<b>PART 3 – SITING THE DEVELOPMENT</b>	
<b>Development objectives</b>	<b>Assessment/Comment</b>
<p style="background-color: #f4a460; color: white; padding: 5px;"><b>Objective 3A-1</b></p> <p style="background-color: #f4a460; color: white; padding: 5px;">Site analysis illustrates that design decisions have been based on opportunities and constraints of the site conditions and their relationship to the surrounding context.</p> <hr style="border: 1px solid #f4a460;"/> <p style="background-color: #f4a460; color: white; padding: 5px;"><b>Design guidance</b></p> <p style="background-color: #f4a460; color: white; padding: 5px;">Each element in the Site Analysis Checklist should be addressed (see Appendix 1)</p>	<p>A site analysis has been submitted with the subject application which identifies the constraints and opportunities of the site</p> <div style="text-align: center;">  </div>
<p style="background-color: #f4a460; color: white; padding: 5px;"><b>Objective 3B-1</b></p> <p style="background-color: #f4a460; color: white; padding: 5px;">Building types and layouts respond to the streetscape and site while optimising solar access within the development.</p> <hr style="border: 1px solid #f

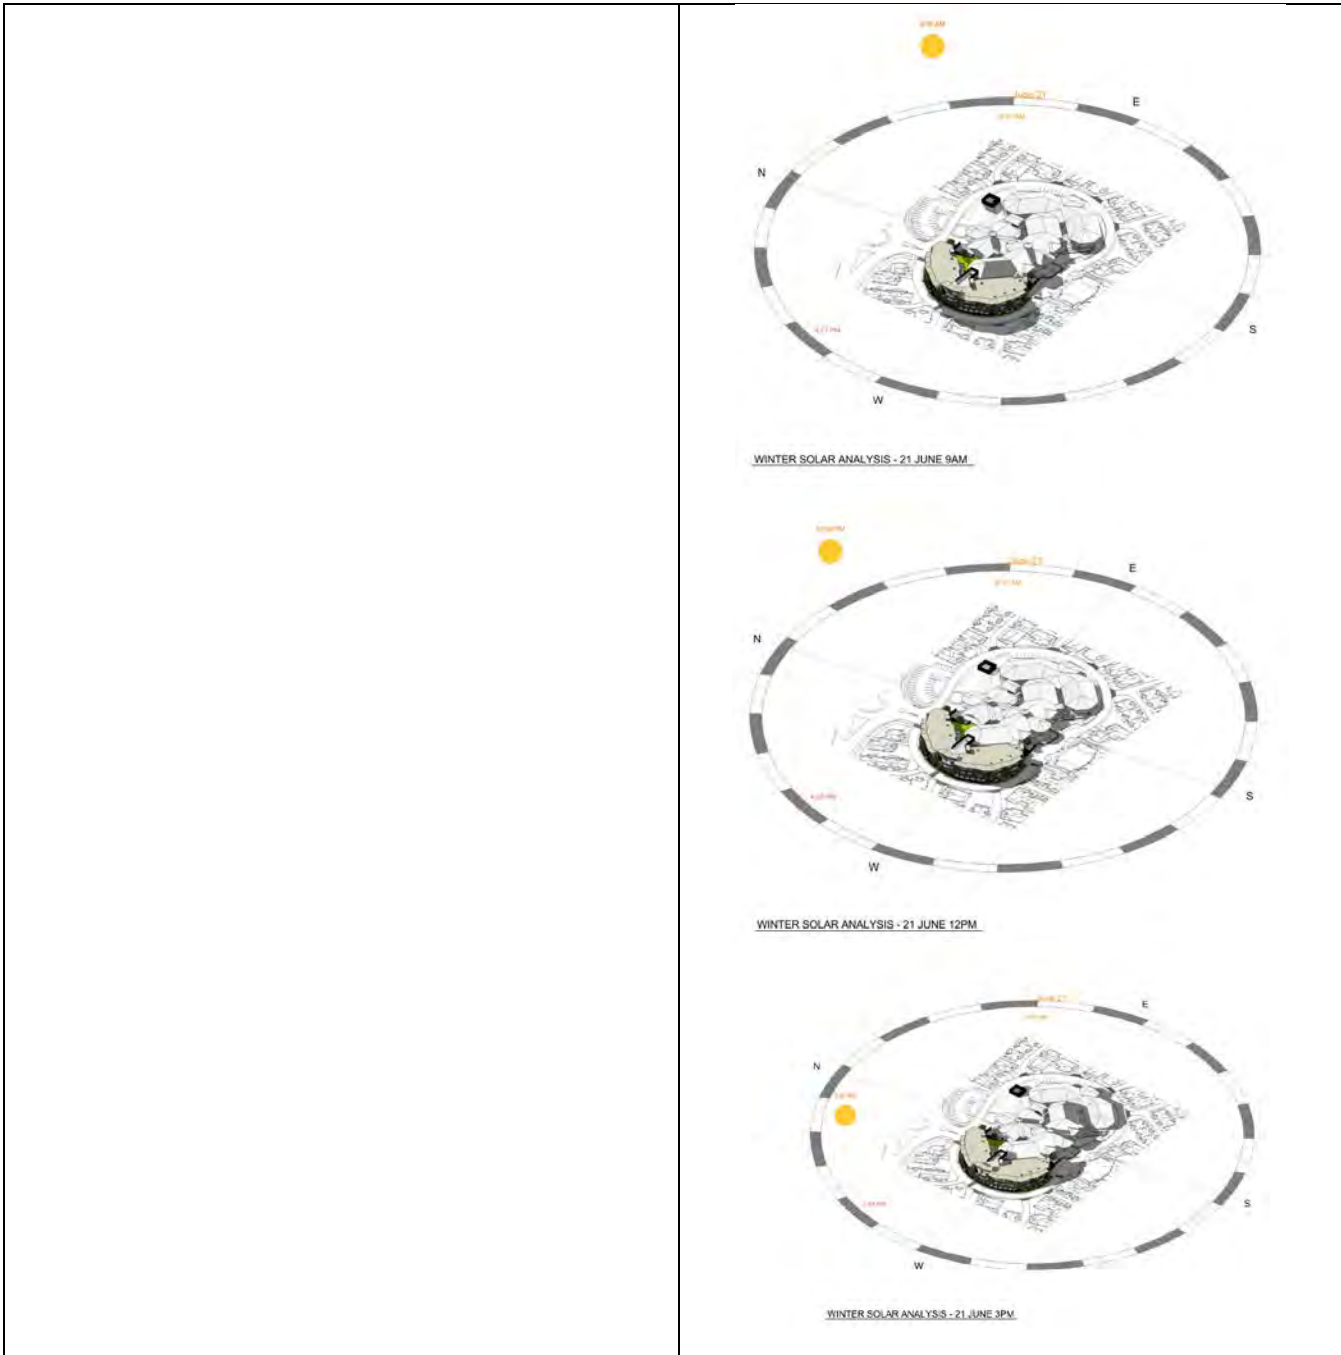
This section of the ADG advises that the subject application is required to provide solar access in accordance with 3D and 4A. The proposed development is considered to comply, please refer to these sections of this assessment for a full assessment.

Notwithstanding the following table includes a breakdown for the proposed apartments

The solar access to living rooms, POS areas and balconies of adjoining properties is considered minimal. From the submitted shadow diagrams – the following is applicable at 21 June.

It considered that any adjoining dwellings which benefit from Solar will not be affected, the site is irregular in shape, however it is generally considered that the building is oriented 90 degrees to the boundary. The adjoining properties are separated from the proposed development by the internal access road, this separation has decrease the potential overshadowing impacts.

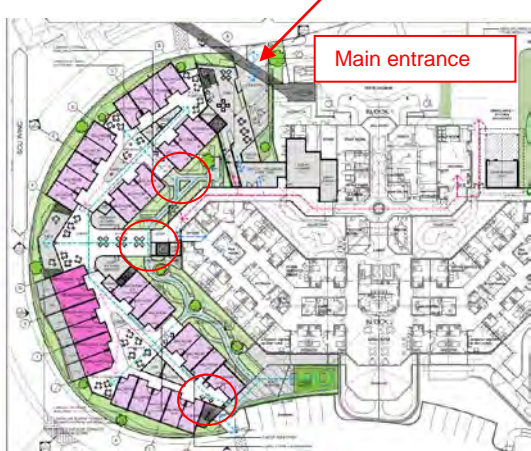
<p><b>Objective 3D-3</b> Communal open space is designed to maximise safety</p> <p><b>Design guidance</b></p> <p>Communal open space and the public domain should be readily visible from habitable rooms and private open space areas while maintaining visual privacy. Design solutions may include:</p> <ul style="list-style-type: none"> <li>• bay windows</li> <li>• corner windows</li> <li>• balconies</li> </ul> <p>Communal open space should be well lit</p> <p>Where communal open space/facilities are provided for children and young people they are safe and contained</p>	<p>The design of the development includes, central eating/dining/communal areas at levels 1 and 2, with associated POS areas overs looking the communal areas with applicable. At ground level the areas where applicable present to these areas.</p> <p>North/Street elevation:</p>  <p>Western elevation (viewed from onsite)</p>
